FTI-TLP4: Vehicle Coverage and Preparation Notes

Overview: Mis-Wired door lock connector, field repair required.

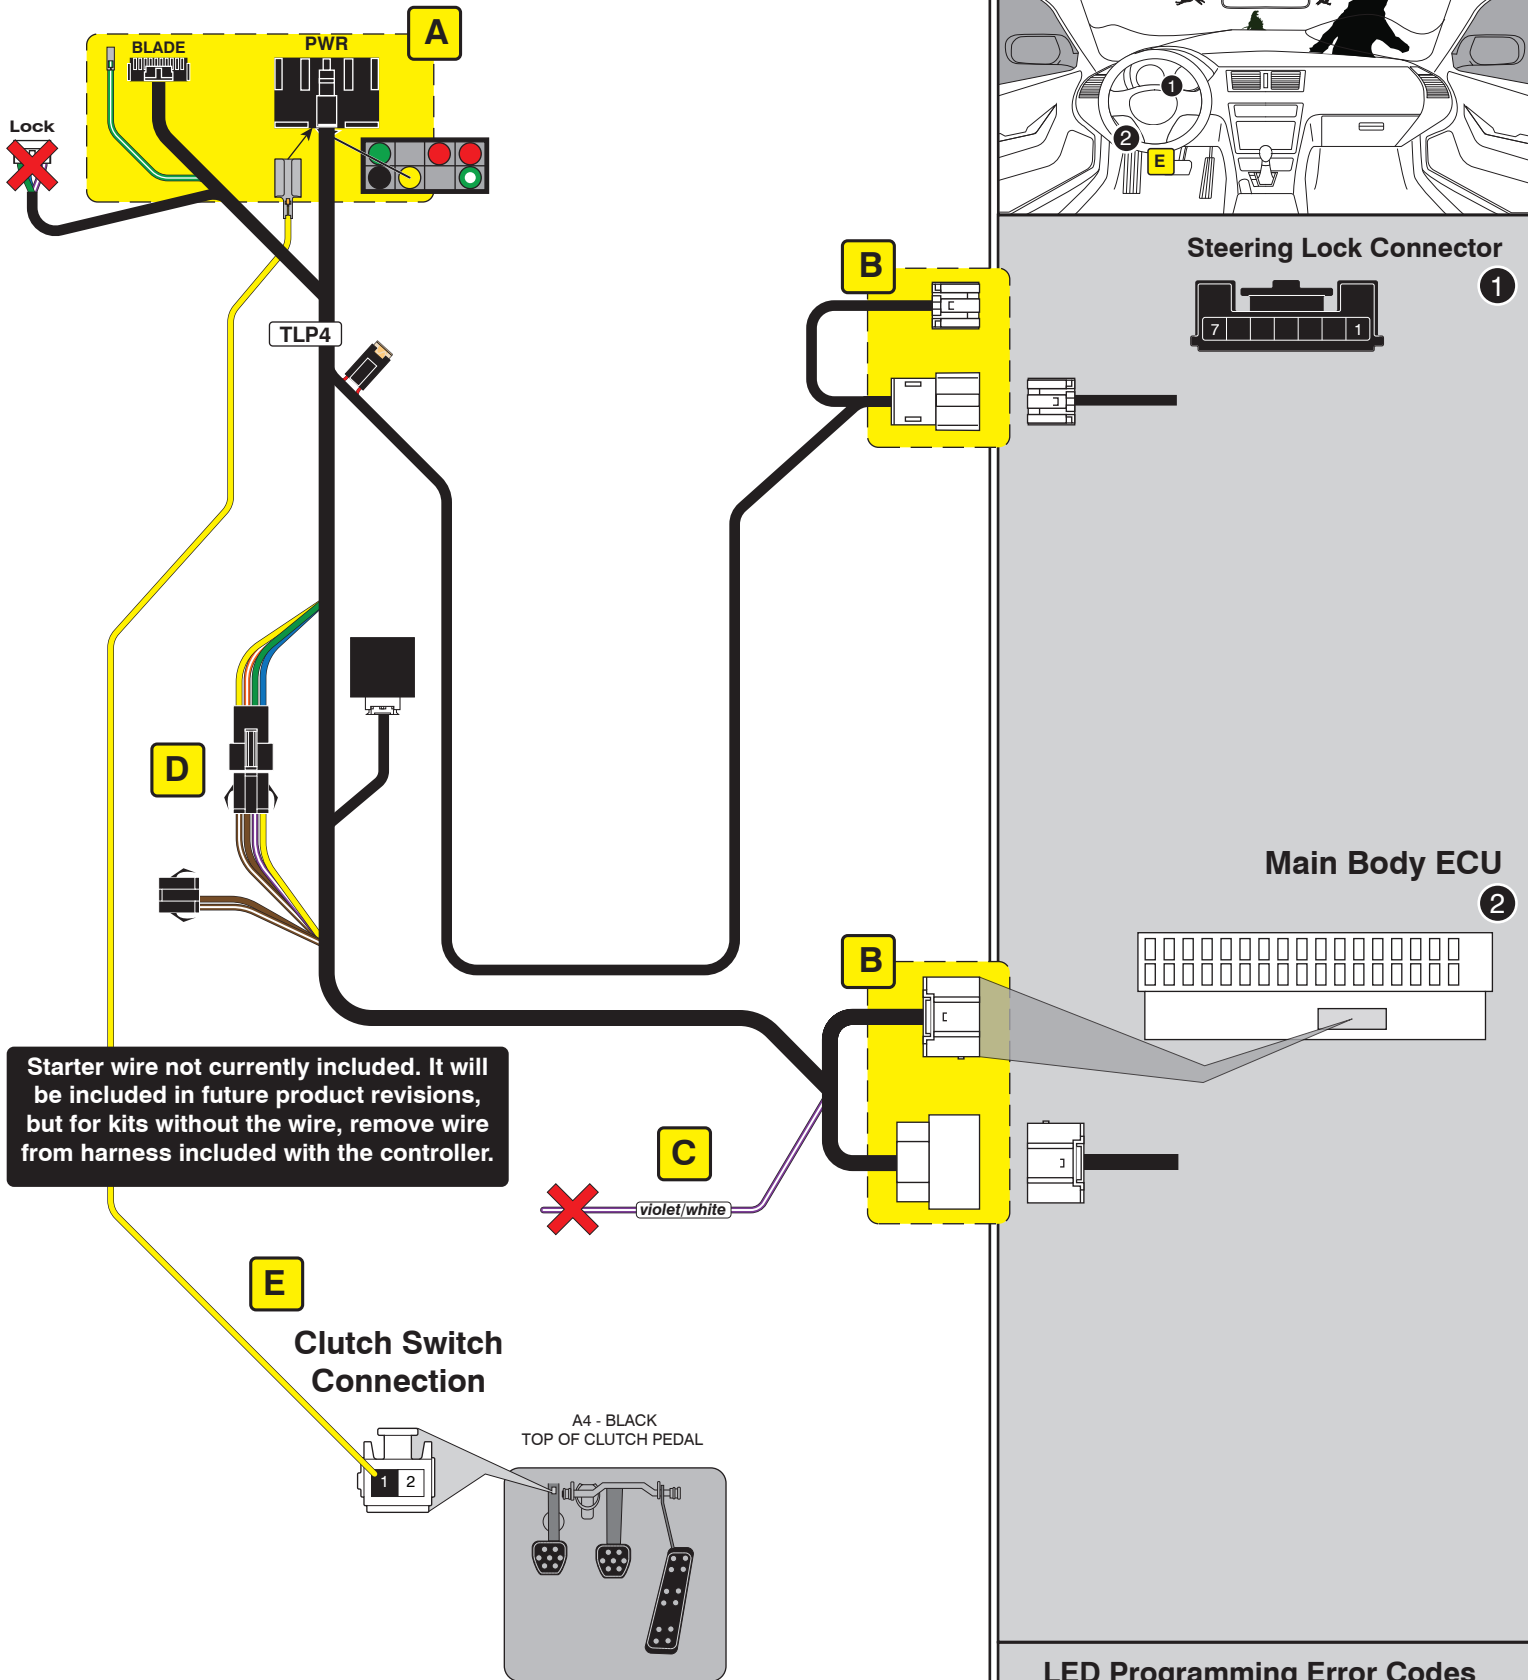
Issue: A review of the latest samples of **FTI-TLP4 T-harnesses** has revealed a misplaced trunk output wire in the 6-pin Lock Accessory Connector requiring that the wire be relocated to the correct position, to ensure safe operation when used. **Using the harness without addressing the issue will result in failed trunk/hatch control, and possible damage to the vehicle BCM.**

Correction: The harness purple/white wire in the latest production run of FTI-TLP4 harnesses has been inserted in the position normally used for the +12V power connection in the accessory harness. Before completing the installation, the installer must relocate the harness purple/white wire to the correct position, 1 space inward on the 6-pin connector, see illustrations below in Fig. 2.

To relocate the terminal, using a fine pick or Olfa type knife, depress the terminal locking barb and pull the purple/white wire from the connector housing. Once the terminal has been removed from the housing, again using the pick or knife, lift the locking barb about 1/16" (1.5 mm) and reinsert the terminal in the correct position. If upon initial examination of the harness the lock accessory connector looks like the illustration in Fig. 2, no modification is necessary, the wire is in the proper position.
